TOWN OF PONCE INLET, PLANNING AND DEVELOPMENT DEPARTMENT

To: Historic and Archeological Preservation Board  
From: Michael E. Disher, Senior Planner MD  
Date: January 26, 2016  
Subject: Consistency determination of plan modifications with Certificate of Appropriateness, Case No. CA15-02

**REQUEST:** To determine whether a new proposed conceptual design plan modification is consistent with the Certificate of Appropriateness approved in June 2015 for an addition to the front of the house

**LOCATION:** 46 Oceanview Avenue

Design Approved with Certificate of Appropriateness on 6-4-15

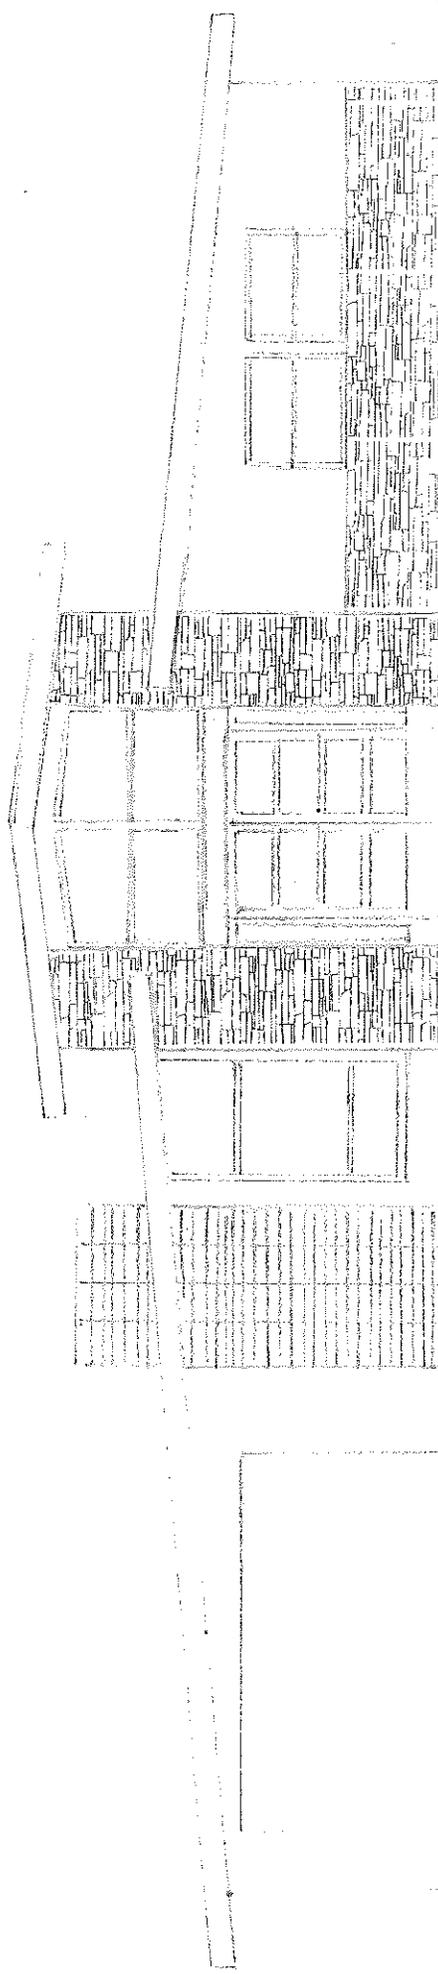
Specifically, the approved design incorporated the following features:

- raised 2-3 foot tall elevated entrance "tower" with large windows
- tower roofline consistent with the existing roof slope and horizontal building proportions
- thin stonework blocks that reinforce the building's horizontal orientation
- wide stonework pilasters framing the front entrance
- retaining the existing brick chimney and plate window on the left (west) side of the entry
- new energy-efficient doors and windows to match the appearance of the existing ones, with horizontal glass panes
- no elements introduced from other architectural styles

# New Revised Design: 1-20-16

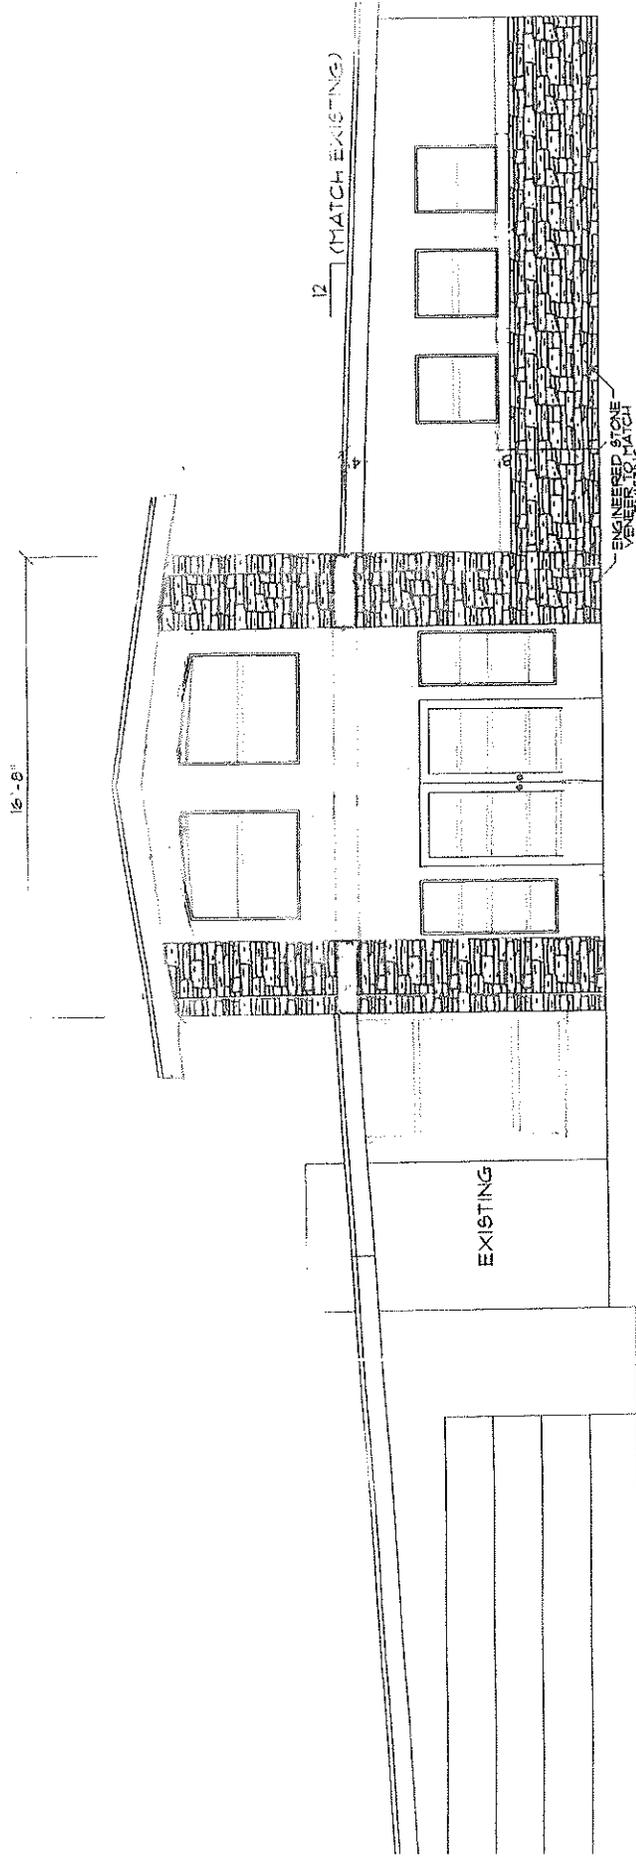
room (**Attachment E**). Staff supports this new proposal as a compromise that provides the additional space desired by the applicant yet maintains the building's historic architectural character. Key features of this conceptual design include:

- 6' ceiling height of upstairs room to reduce the vertical interruption of the building's horizontal profile. Note: rooms with less than a 7' ceiling may only be used for storage per the Florida Building Code.
- 1:12 roof pitch of upstairs room to match that of the existing roofline
- 4" roof eave fascia on the upstairs room to match the existing roof fascia
- reduced angle of upstairs windows to match the roof pitch
- thin aluminum framing around doors and windows
- doors and windows with multiple horizontal panes to match those existing
- wide (18" minimum) stonework pilasters on either side of the entrance
- continuous window sill under the three new windows to the right of the entrance
- horizontal band, continuous with existing roof line, across the front of the new entrance, between the ground floor and upstairs room

These features are intended to reinforce the low, wide characteristics of the building's historic architectural style and minimize the vertical interruption of the horizontal profile created by the upstairs room. Staff has received informal input from Volusia County's Historic Preservation Officer that the new design would function well as a compromise that is much more in keeping with the mid-century Ranch style. On January 20, 2016, the applicant indicated to Staff that these changes would be acceptable and that he would like to proceed to the next Historic Board meeting on February 4, 2016 to request a determination of consistency with the new design.

Based on the findings of this report, Staff recommends the Board find the new conceptual design in **Attachment E** to be *consistent* with the approved COA issued June 4, 2015. Staff's recommendation is conditioned on the applicant revising the building construction plans for permit application no. 2015-0984 to be consistent with the Board's final determination.
